COMMENT #40

From: Deirdre McKeel <deirdre.mckeel@gmail.com>
Sent: Sunday, January 18, 2015 11:31 AM
To: Allison Satter
Subject: District 2 Final Plan - unpublished Letter to the Editor

Subject: 2016 Comprehensive Plan Update

Re: Water Quality and loss of infiltration required to develop the former 440 acres know as Port Blakely Joint Planning Area, loss of open space, trails and Heins Lake .

Inset 4. NRCS Color Soil Map (Unit 64: Water), showing three lobes not mapped by Parametrix. North is the top of the page.

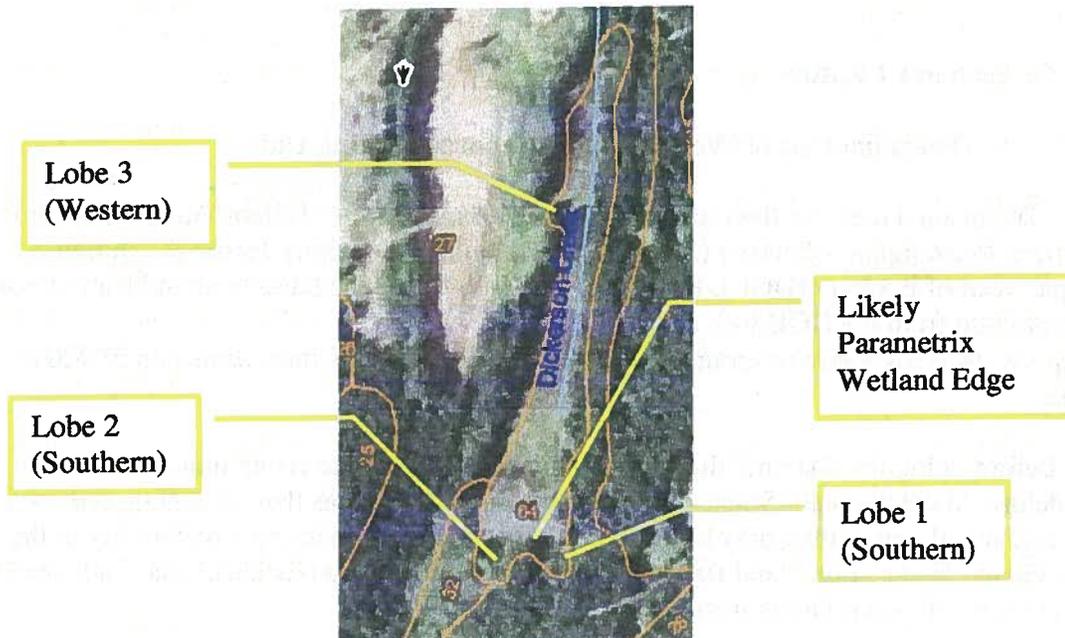
The Wetland 4 boundary observed by LCI in the field was different from the boundary as shown by Parametrix and in the *Mineral Resource Development and Preliminary Reclamation Plan*. Notably, two lobes were found on the south end (Lobe 1 and Lobe 2) that project toward the proposed Quarry C, and one additional lobe (Lobe 3) was found on the western edge. Lobe 2 on the south end has Dickerson Creek running through it, with a defined channel and ordinary high water mark (Photo 24). LCI did not follow the channel to the source, but observed it within the boundary of Wetland 4. Lobe 1 is forested with tree, partial shrub, and herb layers, and mostly inundated soils (see Sample Plot 9). Lobe 1 is the smaller of the two, and is approximately 75-feet wide at the beaver pond end, and approximately 75-feet long (approximately 5,625 square feet or less). Lobe 2 is forested, with tree, shrub, and herb layers, and two western redcedar (*Thuja plicata*) trees were observed near Sample Plot 10 that had diameters greater than 24", and one of those approximately 36" in diameter. The soils in Lobe 2 are mostly saturated at or below the soil surface, with puddles in places. Lobe 2 is approximately 275' wide at the junction with the beaver pond, and approximately 200' long (approximately 55,000 square feet, or 1.26 A, or less).

Dickerson Creek was observed in Lobe 2, and the channel was approximately 5-feet wide at the observation point with a fine gravelly substrate and flowing water. A portion of the Lobe 2 wetland could be flooded by the creek during times of high flows. However, the presence of leaf litter, the location of the wetland at the base of the surrounding hills and the larger size of the wetland indicate that it is not completely inundated by creek flooding (as riverine class wetlands are), so this Lobe 2 wetland is can be classed as a sloped portion of the depressional beaver pond wetland.

Inset 8. Approximate location of Lobe 1, and the proposed stormwater discharge to the Wetland 4 buffer, which is very likely in or near the unmapped Lobe 1 of Wetland 4. (Clipped from *Mineral Resource Development Plan*, Sheet C11).

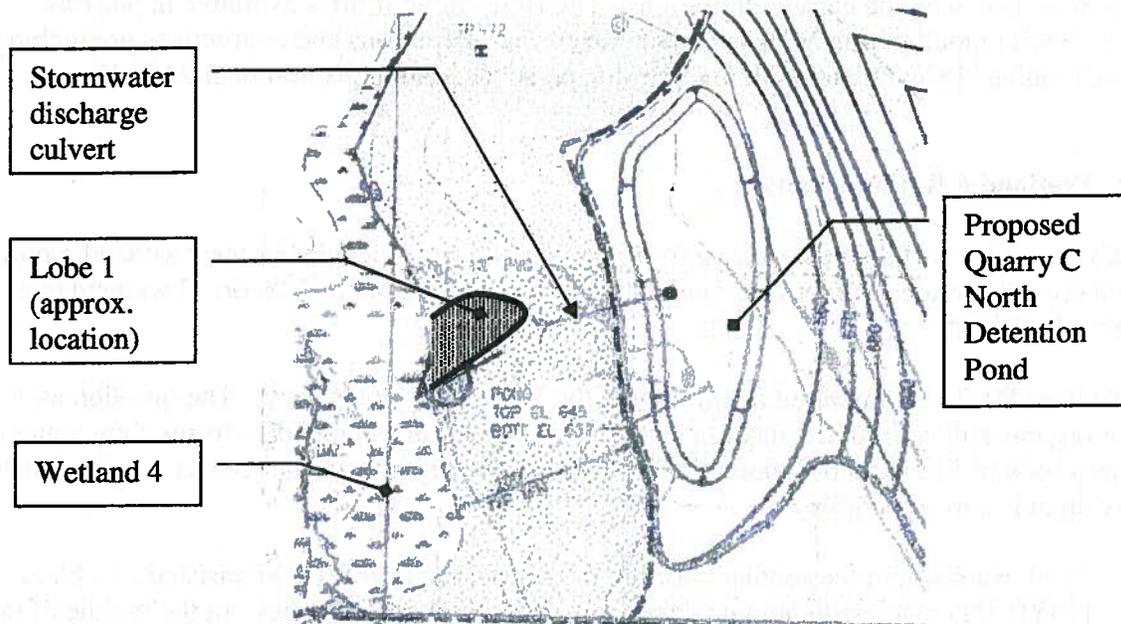
The opportunity to improve water quality will exist after the proposed quarry construction, since the proposed Quarry C North detention pond is shown to discharge to a topographic low point in the Wetland 4 buffer about 120' from the edge on the map (*Mineral Resource Development Plan*, Sheet C11). In reality, that topographic low point is either in or very close to the unmapped Lobe 1. Because 50% of the stormwater will be untreated (see **F. Wetland 4 Hydrology and Proposed Quarry Stormwater Plan** herein), and because the rating manual says even treated stormwater is polluted (p. 45, comment 38), Wetland 4 will have the opportunity to improve water quality after construction.

Although the Construction Notes on Sheet G2 say that deviations from the plan may be necessary (General Erosion & Sediment Control Notes, Note 6), which means the exact culvert discharge point could deviate from the plans, the topographic low point will not change, and the stormwater will flow to that topographic low point which could be Lobe 1 of Wetland 4.

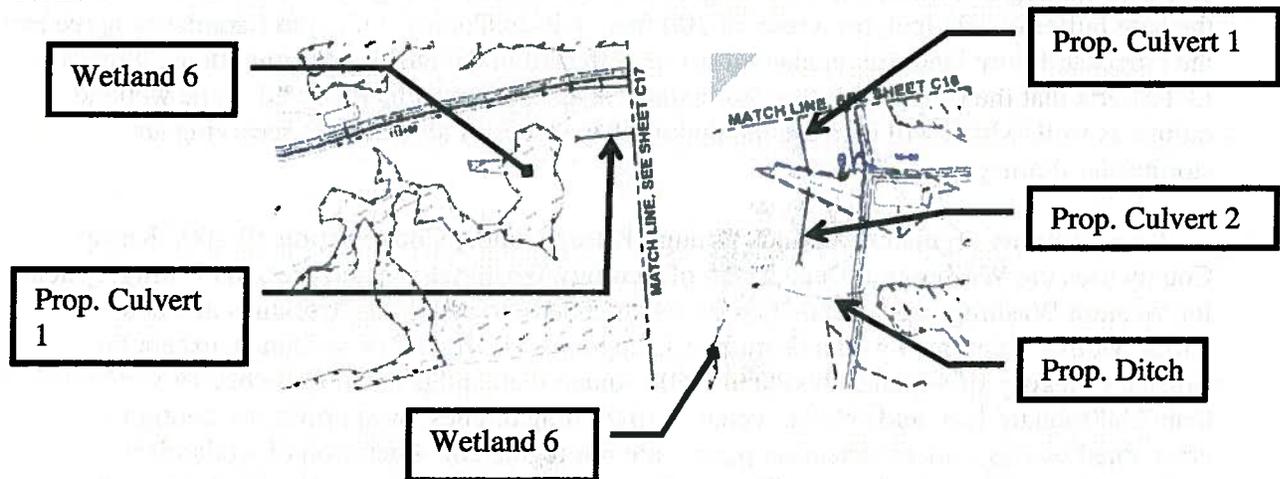
Like Wetland 4, the opportunity will exist for Wetland 6 to improve water quality after the proposed quarry and road construction, since the proposed roadside detention pond is shown to discharge to a topographic low point in the Wetland 6 buffer (*Mineral Resource Development Plan*, Sheets C20 and C21), and will likely cause stormwater to enter the wetland. Because 50% of the stormwater will be untreated (see **F. Wetland 4 Hydrology and Proposed Quarry Stormwater Plan** herein), and because the rating manual says even treated stormwater is polluted (p. 45, comment 38), Wetland 6 will have the opportunity to improve water quality after construction. All wetlands receiving treated and untreated stormwater from the proposed roads will also have the opportunity to process pollutants, so the post-construction ratings may change for any wetland that currently does not have the opportunity box checked on its respective rating form.
